LAND USE BOARD APPLICATION

As requested, we have reviewed the above referenced application in accordance with the Borough of Highlands Zoning and Land Use Regulations. The Applicant seeks to extend an existing deck and construct a new deck to the second story and is seeking bulk variances. The Applicant received a Denial of Zoning Permit on February 3, 2025, for non-compliance of bulk requirements and must seek Planning Board approval.

As requested, we have reviewed the above referenced application in accordance with the Borough of Highlands Zoning and Land Use Regulations. The Applicant is seeking bulk variances for the construction of two decks. The Applicant seeks to remove the existing wood deck, construct a flat deck (11'-9"x 19'-9") located above a rear portion of the first story of the existing dwelling with a proposed stairway to a proposed lower and slightly larger wood deck (13'-9 ½"x 19'-9") and proposed stairs to the existing patio. The Applicant received a Denial of Zoning Permit on February 3, 2025, for non-compliance of bulk requirements and must seek Planning Board approval.

- Copy of a plan set entitled, "Kubis Residence, 260 Navesink Avenue, Highlands, New Jers

TOPOGRAPHICAL SCALE: 1" = 20'-0'

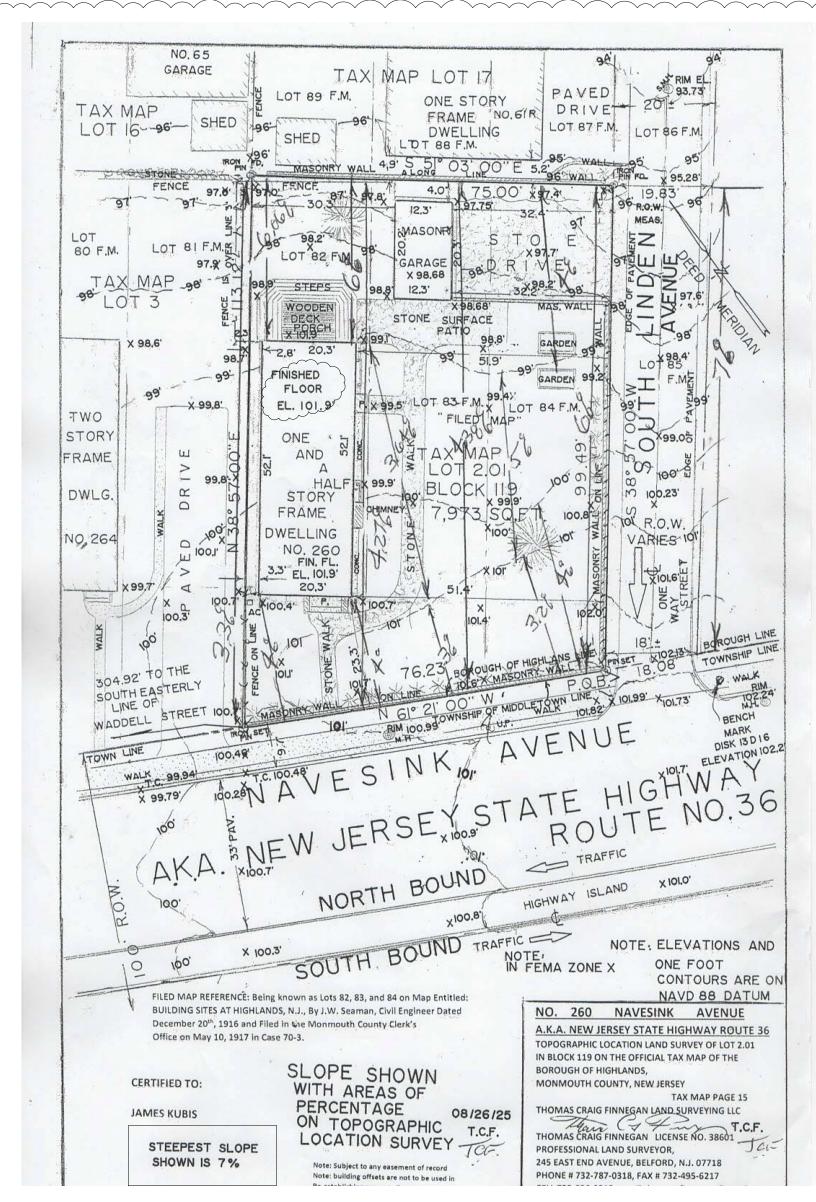
According to §21-84-B is located within the Steep Slopes Area.
 Please indicate the slope area(s) on the plan and determine if a permit is required.
 Provide a note on the plan regarding the findings of the Steep Slope review.

Please update the zoning data table. The minimum side yard is noted as 2.8 ft., however the plan states 2.3 ft.

- 3. There are no rear yards for corner lots. According to §21-8 Definitions. Please update the zoning data table.
- 4. A variance appears to be required for the proposed deck. Please provide dimensions and confirm. Please refer to § 21-65.27.
- 5. A variance is required for the lot depth.
- 6. Please provide the building height according to § 21-8.
- 7. There are two decks proposed for the lot. One is a proposed flat deck located above a rear portion of the first story of the existing dwelling with a proposed stairway to a lower proposed ground level wood deck. The Applicant has indicated that the wood deck is replacing an existing deck.

According to the Architectural plans the proposed wood deck is much larger (length and width) than the existing deck and requires footings.

The Applicant is required to provide existing and proposed elevations and determine the impact to steep slopes.

Please provide the 3 ft deck setback lines.

Please provide the two side yard setback dimensions to the proposed wood deck.

The zoning data table on the plans shall be revised accordingly. Include a deck category on the zoning data table.

TOPOGRAPHICAL SCALE: 1" = 20'-0"

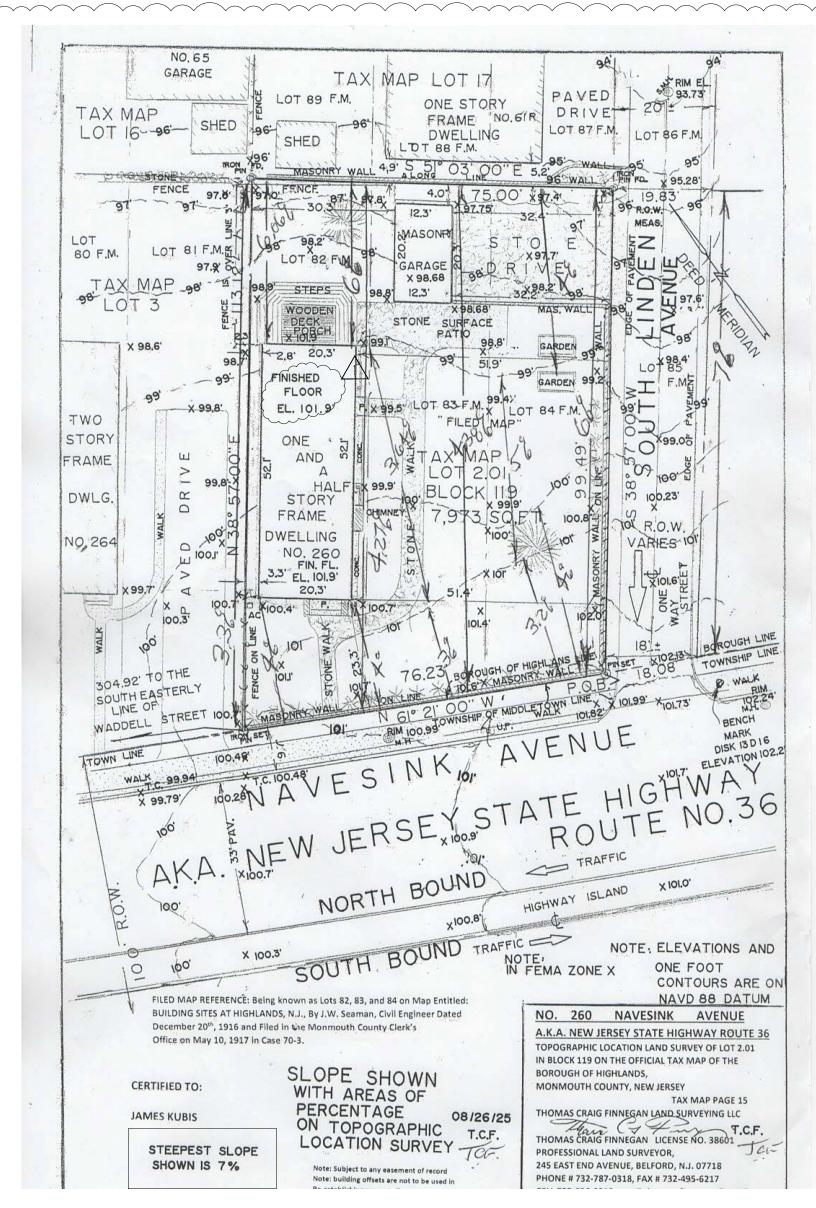
- 1. Please include "Site Plan" in the plan title.
- 2. Please indicate South Linden Avenue and add a north arrow on the "200 Feet Map".
- 3. Please provide a certified list of 200 ft owners on the plan, as required by all land use applications.
- 4. There are two decks proposed for the lot. One is a flat deck (11'-9 ½"x 19'-9") located above a rear portion of the first story of the existing dwelling with a proposed stairway to a lower-level wood deck (13'-9 ½"x 19'-9"). Per the area calculations shown on the plan, the proposed lower-level deck is 42 sf larger than the existing deck.

- a. Please dimension the proposed decks on the plan.
- b. Please provide the 3 ft deck setback lines.
- c. Please update the existing and proposed lot coverages by excluding the area of the lower-level deck. However, please note the areas of the existing and proposed decks.
- 5. Provide elevations for the proposed lower-level deck and at grade on the plan.
- 6. According to the survey, the Applicant's fence encroaches upon adjoining Lot 3 by 3 feet. Coordinate with adjoining owners on possible relocation or encroachment agreement.
